METROPOLITAN GOVERNMENT OF NASHVILLE AND DAVIDSON COUNTY

STAFF RECOMMENDATION
521 Acklen Park Drive
October 21, 2019

Application: New Construction – Infill and Outbuilding
District: Richland-West End Addition Neighborhood Conservation Zoning Overlay
Council District: 24
Map and Parcel Number: 10405007700
Base Zoning: R6
Applicant: Ke Qin
Project Lead: Melissa Baldock, melissa.baldock@nashville.gov

<p>Description of Project: The applicant seeks to construct a new duplex home with a detached outbuilding.</p> <p>Recommendation Summary: Staff recommends approval of the proposed infill duplex and outbuilding with the following conditions:</p> <ol style="list-style-type: none"> 1. The finished floor height shall be consistent with the finished floor heights of the adjacent historic house, to be verified by MHZC staff in the field; 2. Staff approve the roof color, porch floor and steps, windows, doors, driveway material, and walkway material prior to purchase and installation; and 3. The HVAC be located behind the house or on either side, beyond the mid-point of the house. <p>With these conditions, staff finds that the infill and outbuilding meet Section II.B.1 of the design guidelines

521 ACKLEN
PARK DR
SITE PLAN

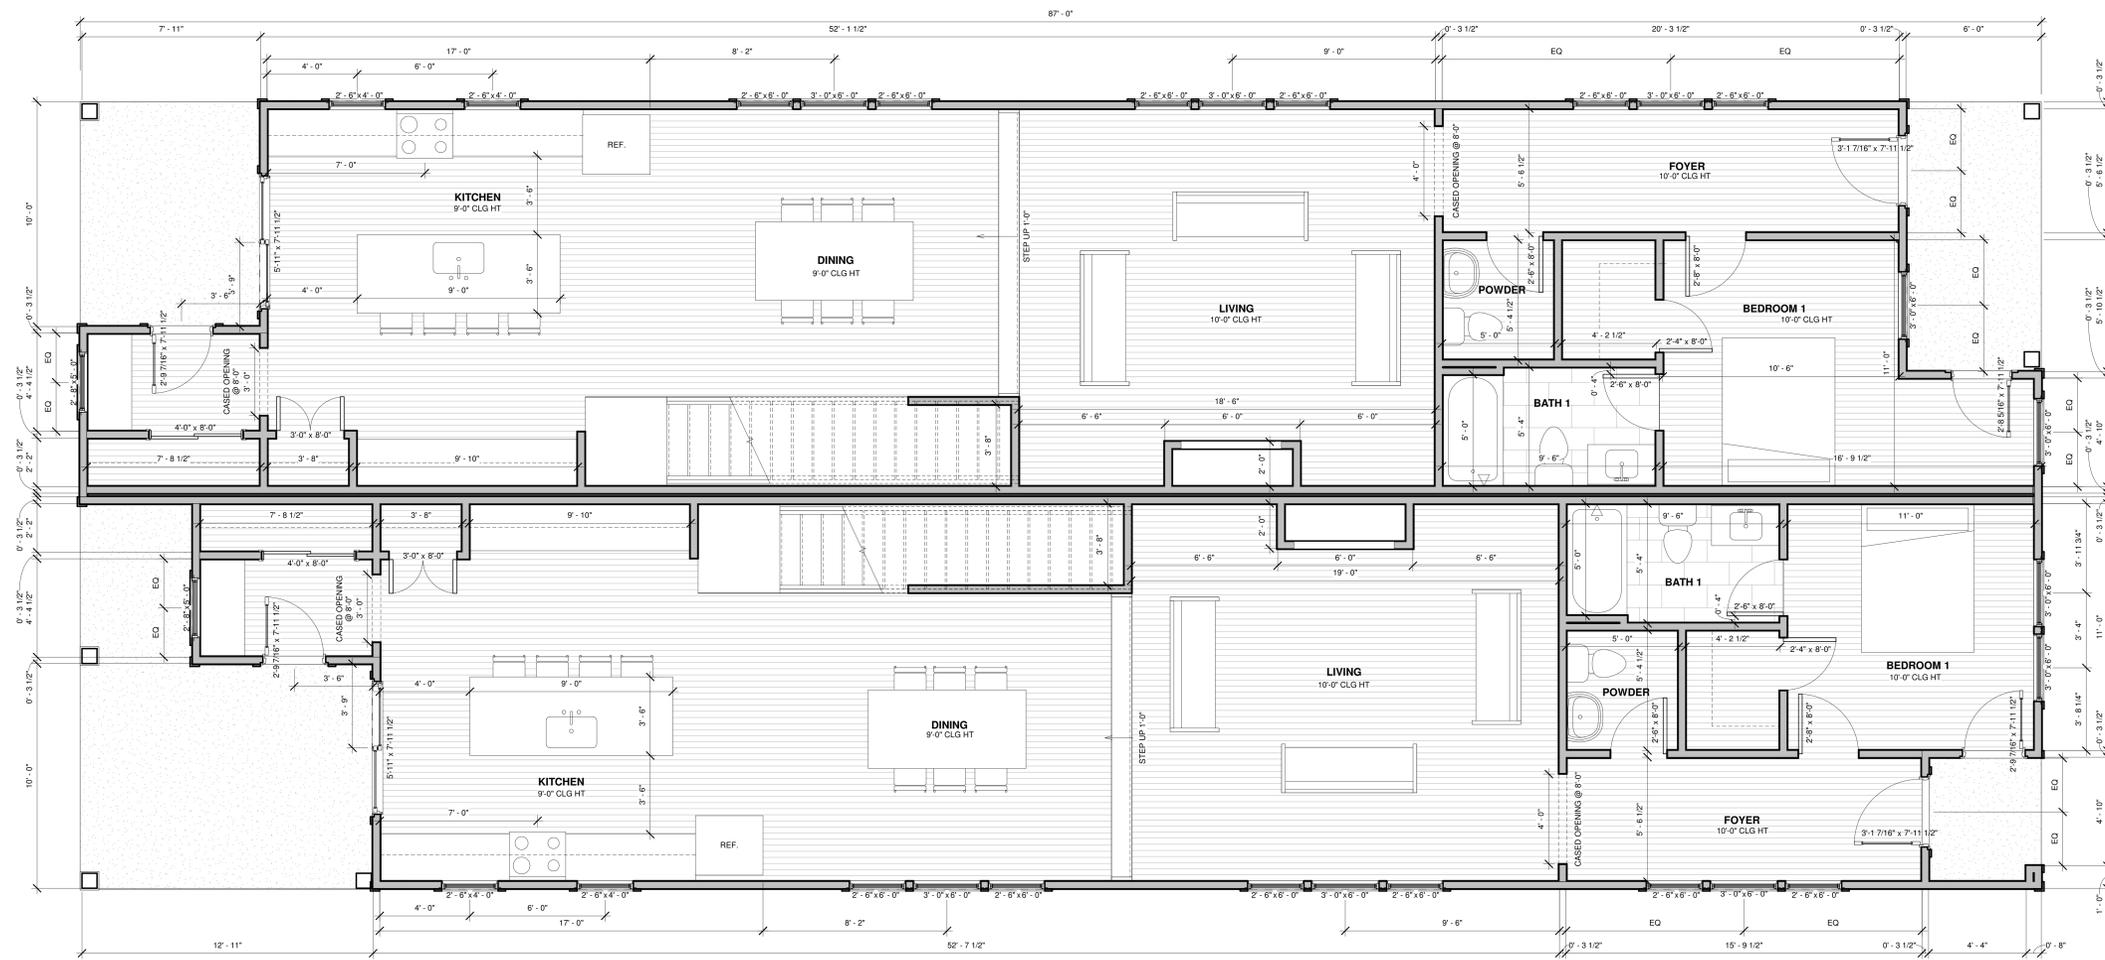
Setback & Rhythm of Spacing: The front of the property is angled to the street, and the front setbacks of the neighboring houses stagger according to the slant of the street. The front setback will be compatible with the front setbacks of the infill houses at 517 and 519 Acklen Park Drive and will follow the established staggered pattern.

The side setbacks will be approximately five feet (5’) from both the left and the right side property lines. The proposed infill will have a rear setback of approximately eight-two feet (82’). The rear and side setbacks meet the requirements of the zoning code and are compatible with the surrounding context.

With the condition that the applicant submit a site plan showing the front setbacks of 519 and 517 Acklen Park Drive, staff finds that the setbacks and rhythm of spacing will be compatible with the surrounding context and will meet Section II.B.1.c of the design guidelines.

521 ACKLEN
PARK DR
ELEVATIONS

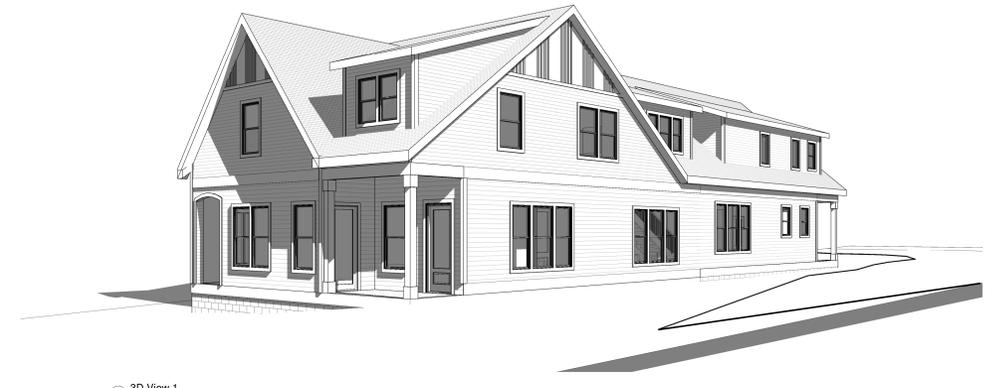
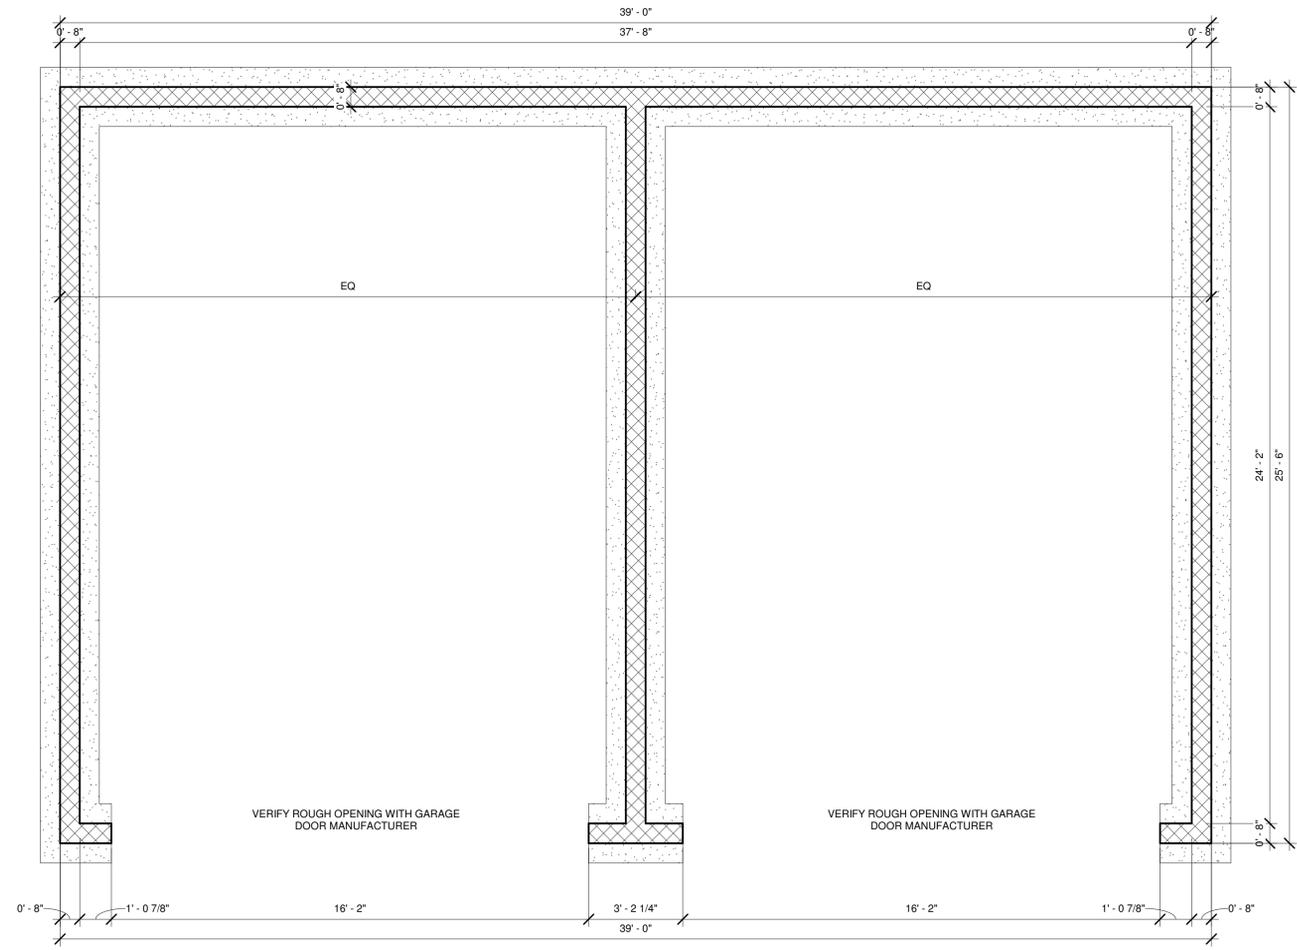
Roof form: The building will have a cross-gabled roof form with pitches of 9/12, 10/12, and 14/12. A shed dormer is proposed on the front façade with a 4/12 pitch. On the side facades are 4/12 shed roofs. All the dormers are inset two feet (2’) from the exterior walls. Staff finds that these roof slopes are similar to the roof forms and slopes on historic houses in this conservation overlay.

Orientation: The duplex will have two doors facing Acklen Park Drive, which meets the historic context and the design guidelines. The left entry will be a vestibule entrance. The right entry will be behind a six foot (6’) deep, partial-width front porch. Vehicular access will be via the alley. Staff recommends that the plan incorporate a walkway or two walkways leading from the front porch and stoop to the street.

Typically, historic duplexes had symmetrical and matching entrances or one shared entrance. Using a vestibule entrance on one end and a porch on the opposite end of the front does not follow historic forms and looks like two different styles of houses combined; however, staff find it to be appropriate here because of the lack of immediate historic context.

Proportion and Rhythm of Openings: The proposed infill’s fenestration pattern is compatible with typical window patterns on historic houses in the conservation overlay. The windows are all vertically proportioned. There are no large expanses of wall space without a window or door opening.

With the condition that the plan incorporate a front walkway, staff finds that the proposed infill will meet Section II.B.1.f of the design guidelines.

521 ACKLEN PARK
DR GARAGE
ELEVATIONS

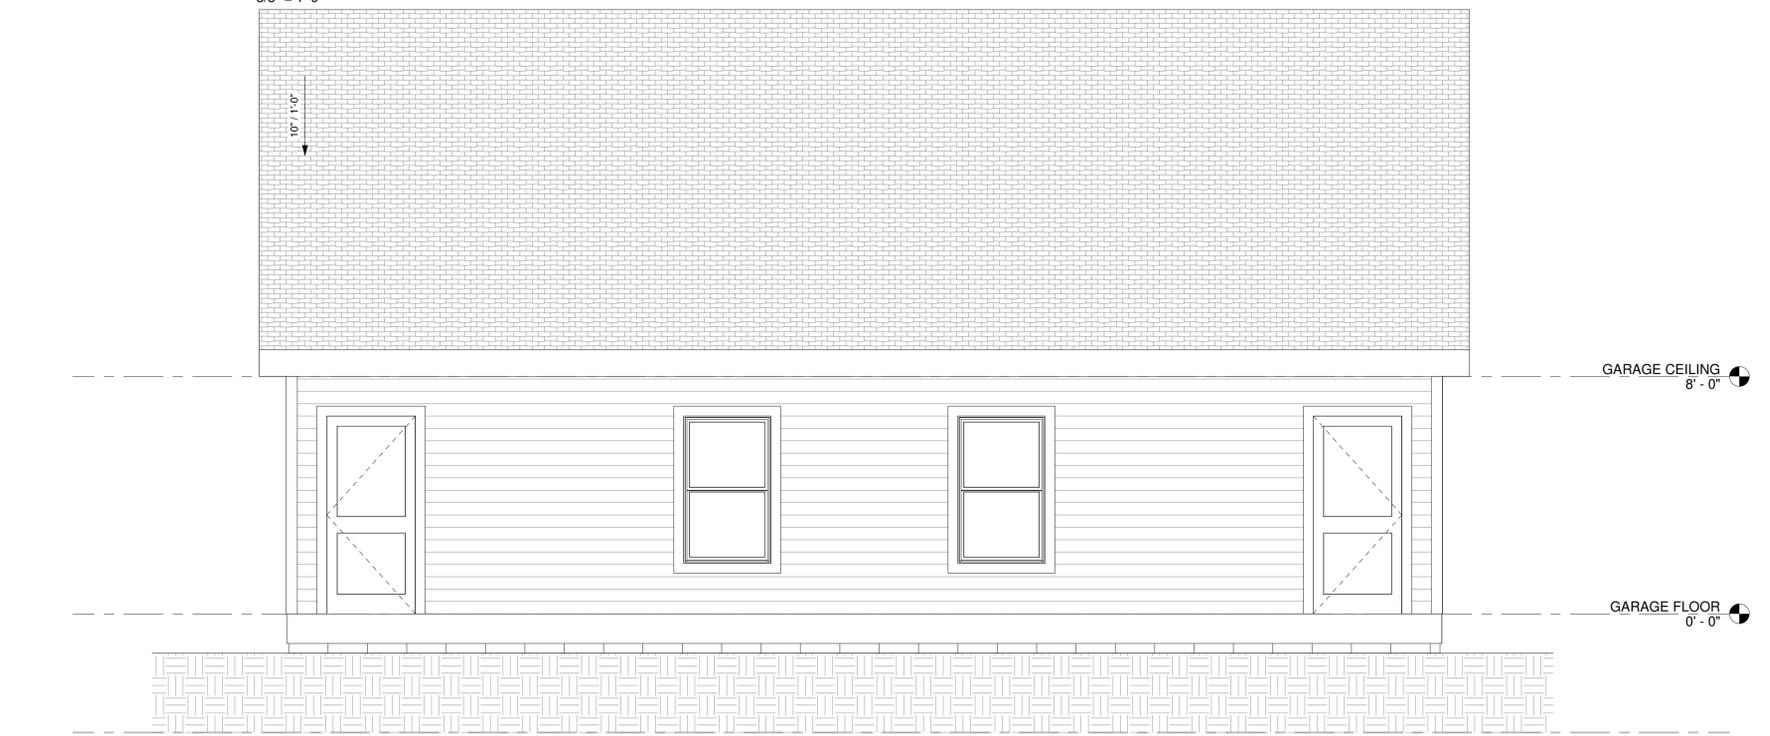
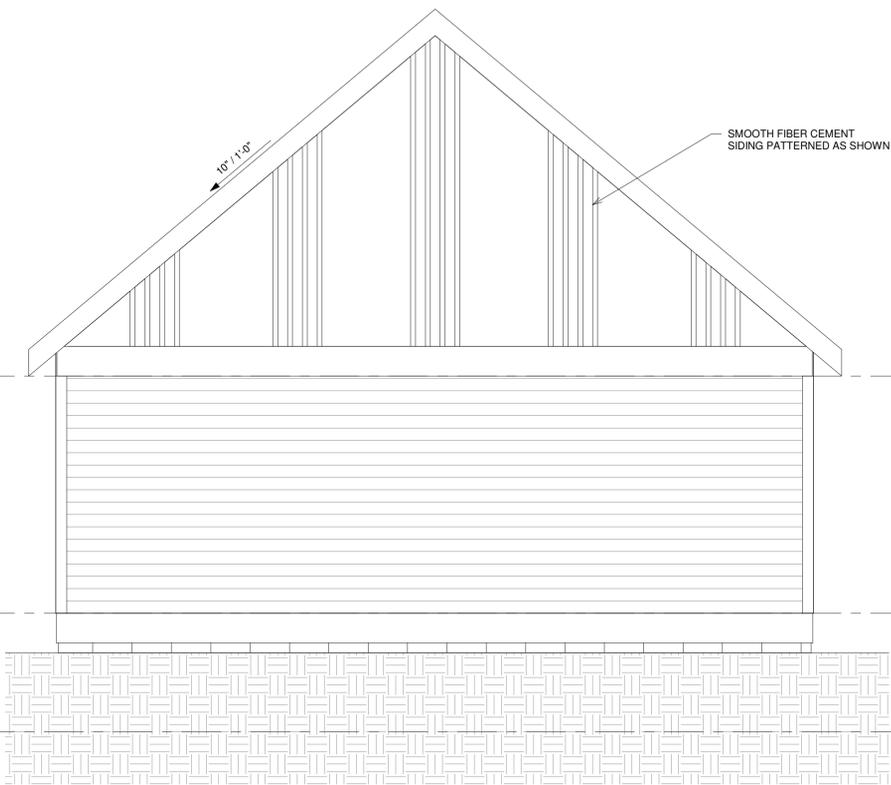
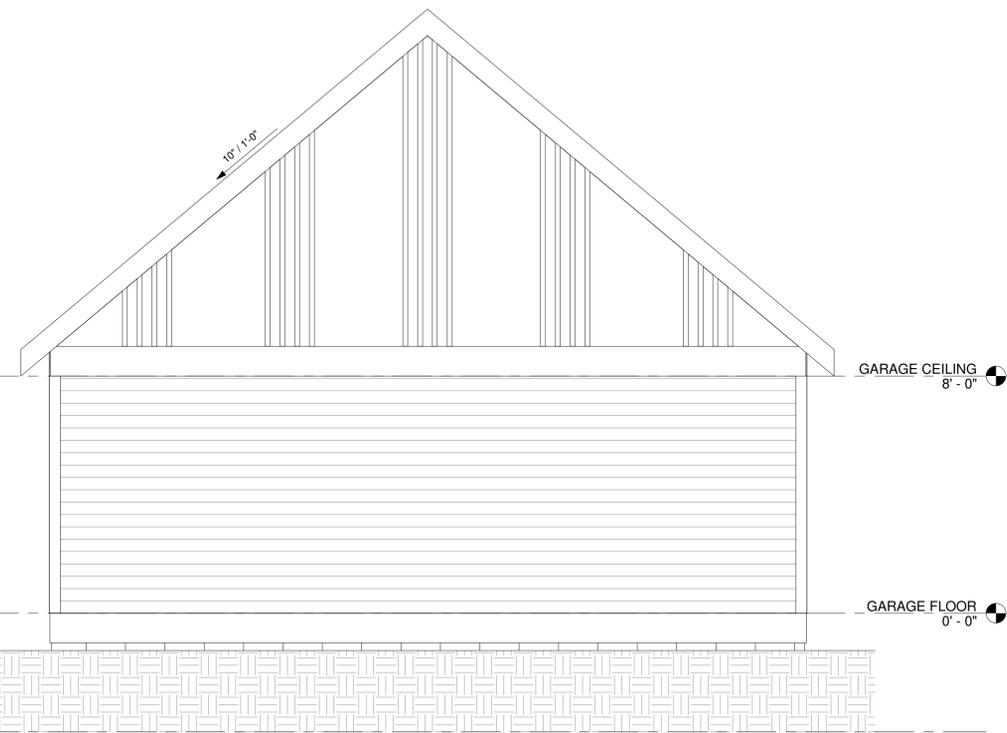
Existing conditions (height of infill)	Potential maximums (heights to be measured from grade)	Proposed (should be the same or less than the lesser number to the left)
Ridge Height	28’6”	25’	20’
Eave Height	11’2”	10’	9’4”

Design Standards: The materials, proportions, and overall character of the accessory structure simple in design and compatible with the infill and surrounding historic context. Its roof form and pitch will match that of the house, and the materials will not contrast greatly with the primary structure. The window proportions and locations are compatible with those of outbuildings historically. Staff finds the design of the proposed outbuilding to meet Section III.B.1.i.1 of the design guidelines.

Proposed Element	Proposed Form	Typical of district?
Primary form	Side gable	Yes
Primary roof pitch	10/12	Yes

With the condition that the roof color, window, and door selections are approved by MHZC Staff prior to purchase and installation, the project will meet Section II.B.1.i of the design guidelines.
